**Windward Development**  
**City of Issaquah**

**BERGSMA PRELIMINARY PLAT**  
**VARIANCE REQUEST**  
**DEVIATION REQUEST**

### DEVIATION REQUEST #3: Road C (local street) Modified Street Section

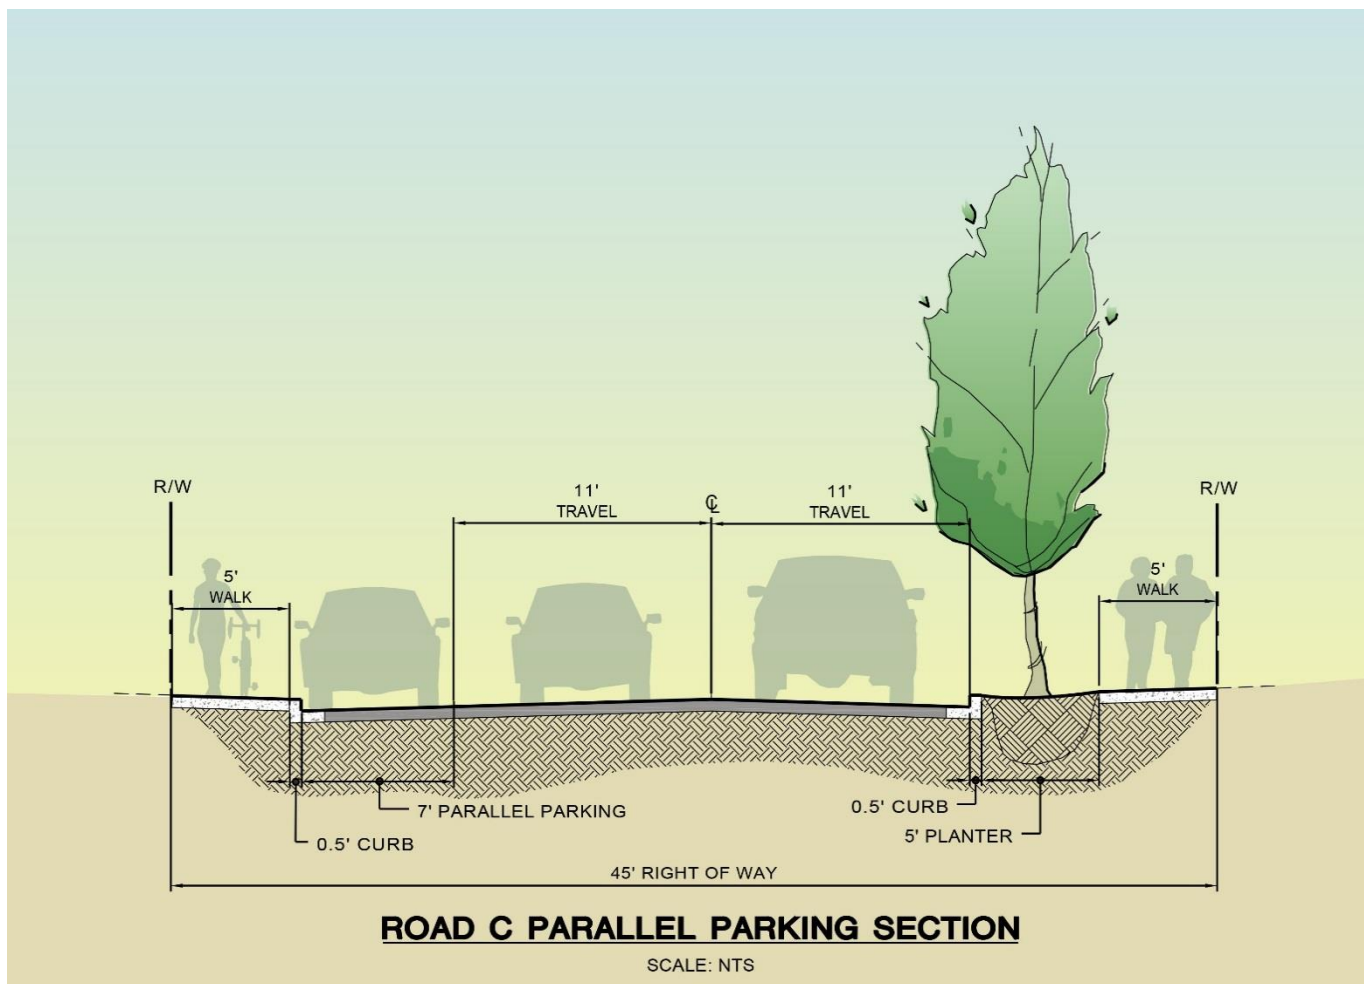
**DESCRIPTION OF DEVIATION:** *The applicant is seeking to modify the identified street standard section to;*

- ***Centerline Street Grade: up to 8%***
- ***Right-of-Way: 45' (min)***
- ***Travel Lanes: Two at 11' each with vertical curb***
- ***Planter strip at back of curb, both sides***
- ***Pedestrian Sidewalk: one side only, south and west sides of street***
- ***Parallel Parking as opportunities on the north and east sides of the street***

The applicant is seeking approval to modify the requirement of the applicable **City of Issaquah, Public Works Department, Typical Public Local Access Street (<1,500 VPD Residential Areas, Standard Detail No. T-11 (11-10-11))** in accordance the following criteria:

1. The deviation will achieve the intended result in equivalent or superior design
  - ***The deviation will provide a conventional residential street for the subdivision. The need for the deviation occurs as a result of the steep grades of the site. The street grade will be limited to 8% to allow for standard conventional driveways, suitable for off-street guest parking on each residential lot.***

- ***Additional guest parking, as parallel spaces, are provided, please refer to the Preliminary Plat Site Plan for locations. The constructed street section will maintain the typical residential look of sidewalk on both sides of the street, separated from the travel land by a vertical curb and tree planted parkway.***

2. The deviation addresses public safety and operation.
  - ***The deviation is designed to provide safe public rights-of-way, containing travel lanes for cars and pedestrian sidewalks separated from the travel lanes. Guest parking is provided at selected locations to supplement parking options for visitors.***

**Windward Development / City of Issaquah**  
**DEVIATION REQUEST #5: Road D (Park Access Road) Modified Street Section**

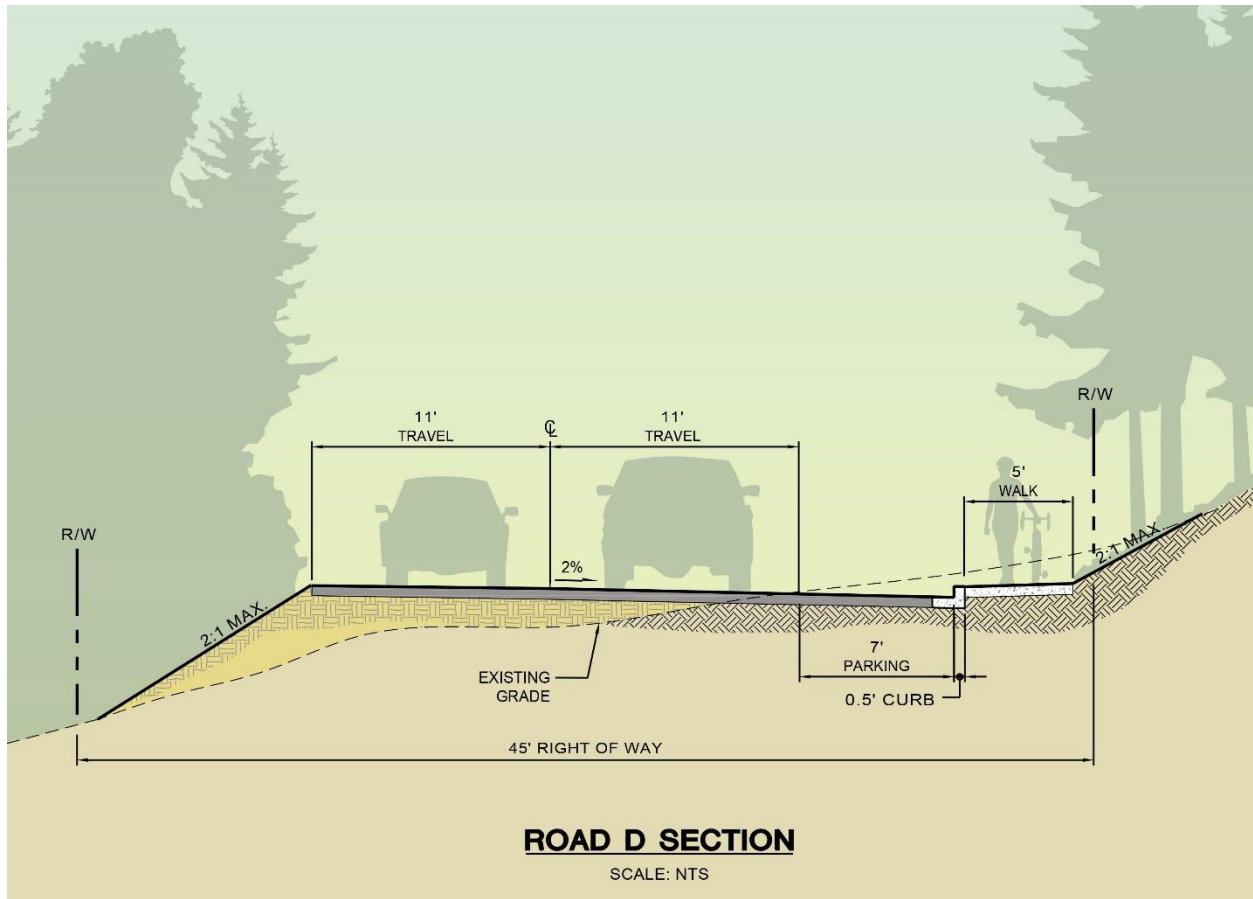
**DESCRIPTION OF DEVIATION:** *The applicant is seeking to modify the identified street standard to;*

- ***Right-of-Way: 45' (min)***
- ***Travel Lanes: Two at 11' each with vertical curb***
- ***No Planter Strip at back of curb,***
- ***Pedestrian Sidewalk: one side only, west side of street***
- ***Parallel Parking as opportunities present on the west side of the street***

The applicant is seeking approval to modify the requirement of the applicable **City of Issaquah, Public Works Department, Typical Public Local Access Street (<1,500 VPD Residential Areas, Standard Detail No. T-11 (11-10-11))** in accordance the following criteria:

1. The deviation will achieve the intended result in equivalent or superior design.
  - ***The deviation will provide for the opportunity to provide guest parking, as parallel spaces as opportunities are available and deletion of the planter strip given the forested context of the road location.***
2. The deviation addresses public safety and operation.
  - ***The deviation is designed to supplement parking options.***
3. The deviation will not adversely affect how well the surrounding nearby public facilities can be maintained:
  - ***The deviation as proposed will not adversely affect surrounding public facilities.***
